Product Change Notification

108546 - 01

Change Notification #: 108546 - 01
Change Title: Intel(R) Carrier Grade Server TIGH2U, PCN 108546-01, Product Material, Added PEM nuts to chassis base allowing support for additional rack mount kits, Reason for Revision: Correct the product name in the title
Date of Publication: June 27, 2008

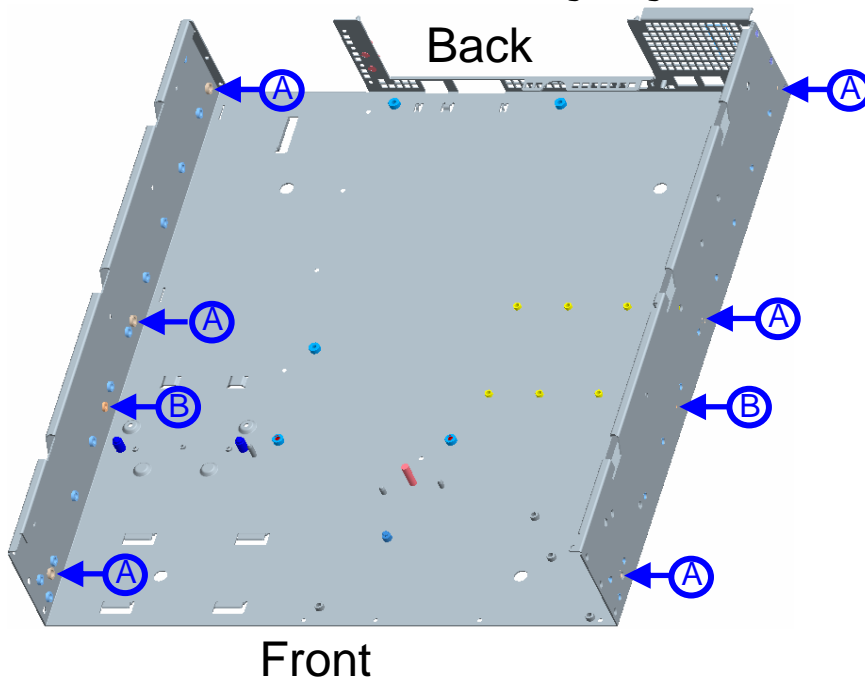
Intel added a total of eight PEM nuts to the sides of the base chassis to enable support for three additional rack mount kits, AXXBASICRAIL, AXXBASRAIL13, or AXXHERAIL. Ordering information for these kits and other accessory items is listed in the Configuration Guide.

Three PEM nuts (size 10-32, labeled "A") and one PEM nut (size 6-32, labeled "B") are added to each side of the base chassis. See locations labeled "A" and "B" in the following diagram.
